ITEM: 17	REPORT SUMMARY MINOR VARIANCE APPLICATION FILE NUMBER A048/25
----------	---

<b>MINOR VARIANCE APPLICATION</b> <b>FILE NUMBER A048/25</b>
---	---

CITY WARD #:	1
APPLICANT:	Samuel Iannucci, Esther Ruth Iannucci
AGENT:	Permit Works
PROPERTY:	122 Chorus Crescent, Kleinburg
ZONING DESIGNATION:	See Below
VAUGHAN OFFICIAL PLAN (2010) DESIGNATION:	Vaughan Official Plan 2010 ('VOP 2010'): "KN Low-Rise Residential I" by Schedule B3 - North Kleinburg-Nashville Secondary Plan (Chapter 11.8, Volume 2)
RELATED DEVELOPMENT APPLICATIONS:	N/A
PURPOSE OF APPLICATION:	Relief from the Zoning By-law is being requested to permit the construction of a pool in the rear yard.

Drawn by EY Date 2024-04-23 Scale As indicated Project Number 23108 DRAWING NAME SITE PLAN

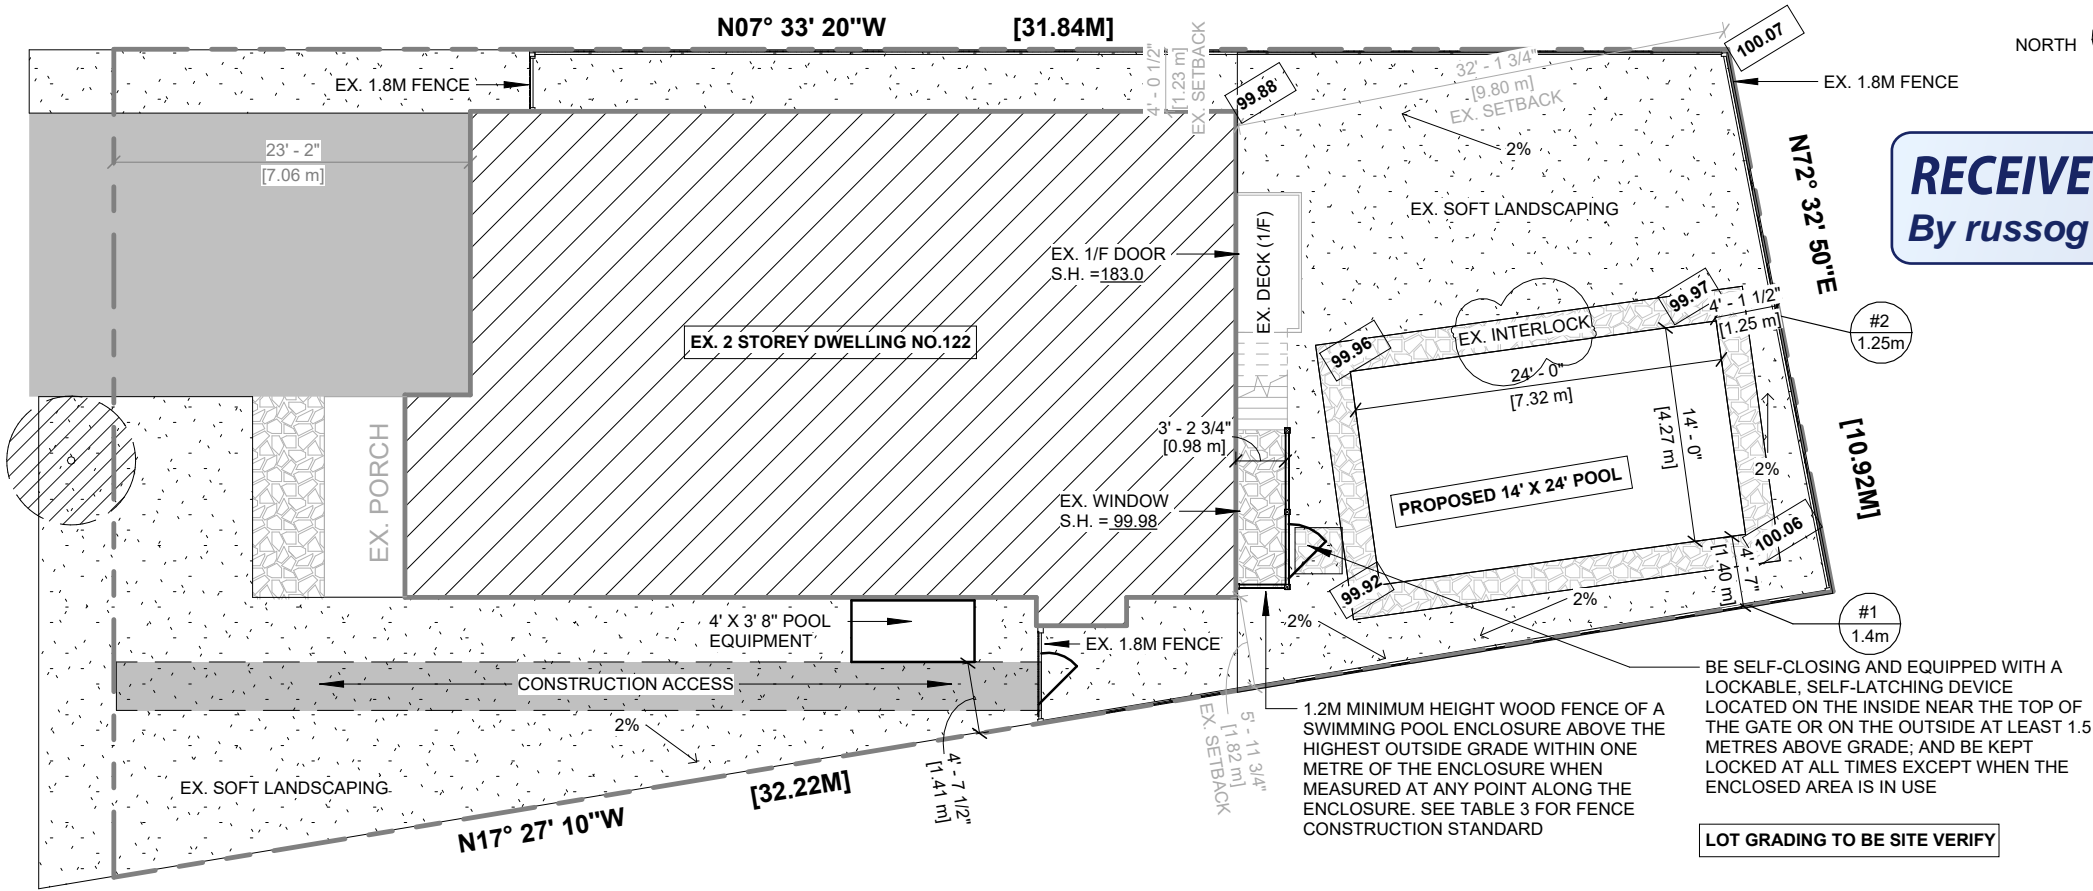
The Development and Parks Planning Department has no objections to Variances 1 and 2 to reduce the minimum setback to 1.25 m from the rear lot line and 1.4 m from the west interior side lot line. A 1.8 m-tall privacy fence exists along the west and rear lot line to mitigate any noise and privacy impacts. The proposed setback reductions provide sufficient separation for access and maintenance around the pool.
